ICHD - ENVIRONMENTAL HEALTH DIVISION

Statesville Office (704) 878-5305 | Mooresville Office (704) 660-3625 | PERMIT # AP 319973

SEPTIC: IMPROVEMENT PERMIT / AUTHORIZATION TO CONSTRUCT / OPERATION PERMIT / EXISTING SYSTEM

SOIL/SITE EVALUATION
for ON-SITE WASTEWATER SYSTEM
(Complete all fields in full)

INITIAL SITE SKETCH

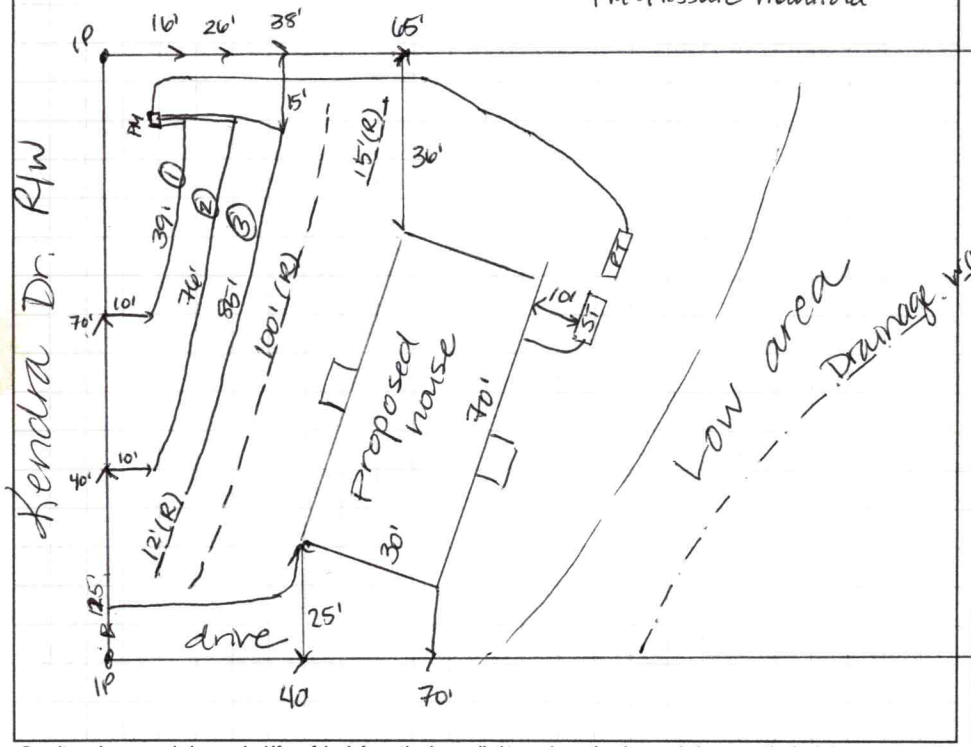
Comments / Conditions: Do not grade or bury utilities in drainfield. Stay 25' from front of house, PM 10' off prop. line. Divert all drainage - finish system to shed water

House cannot move forward on lot - permit will be revoked - house may move back on lot

PLOT PLAN

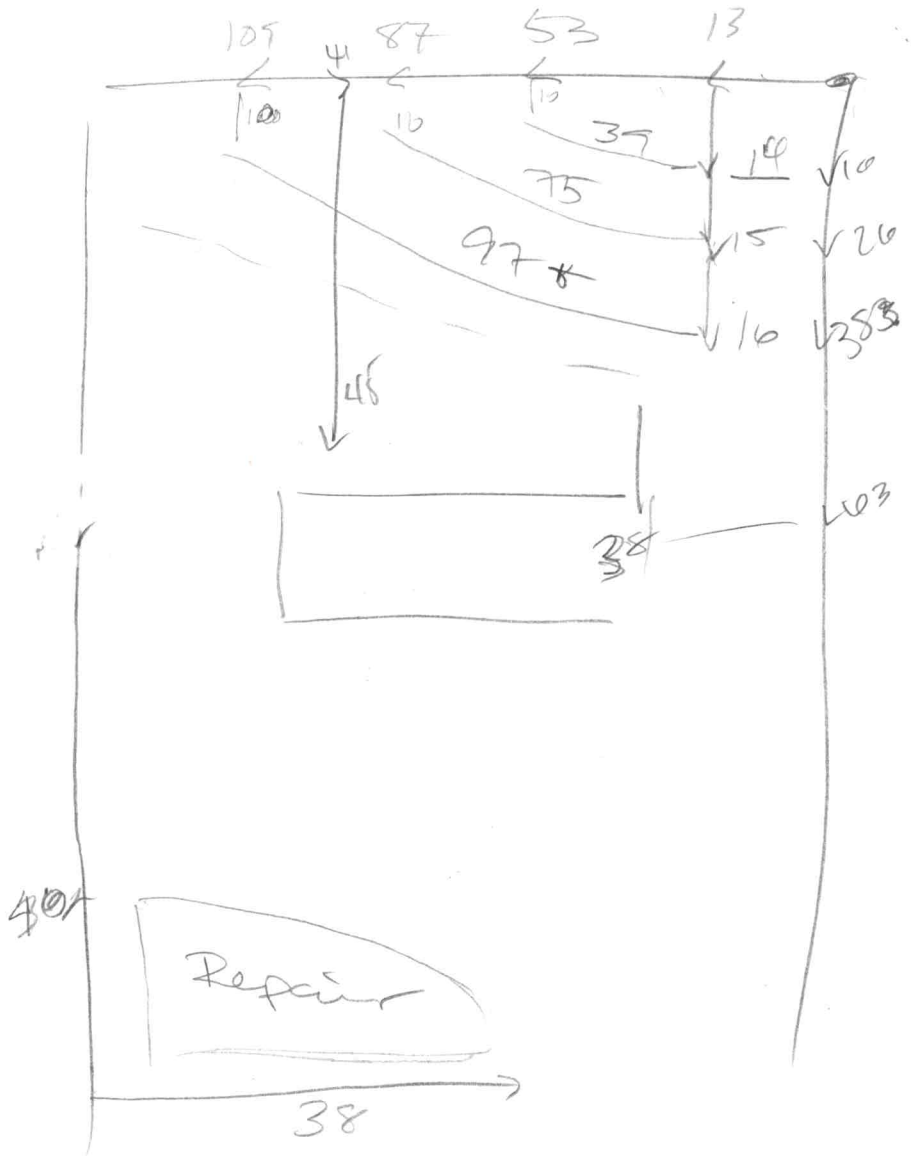
He exactly 25'
from house

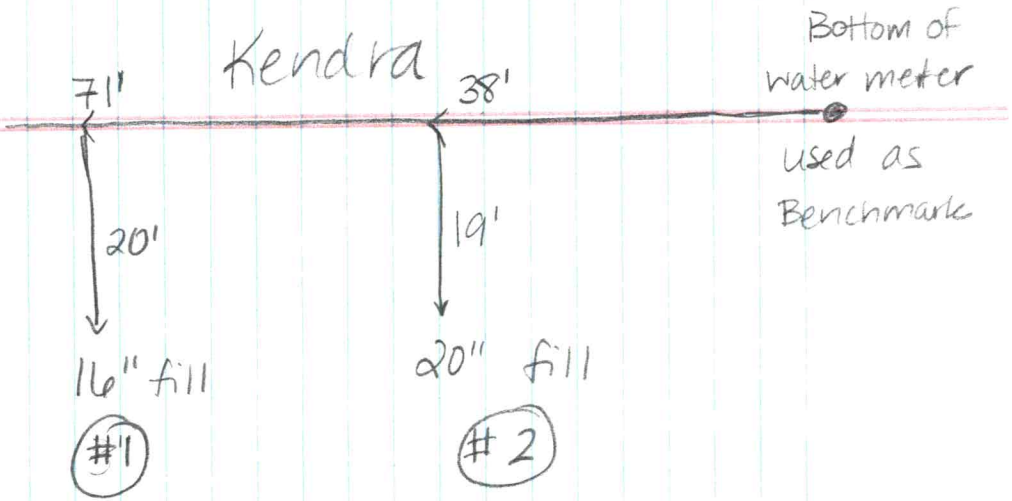
Due to Crawl Space height - not pursuing lot (per Kim Frye @ Freedom)

#1 = 3' elevation difference from benchmark

#2: 3'2" elevation difference

→ take 12" across the entire front of lot (above house) 25'
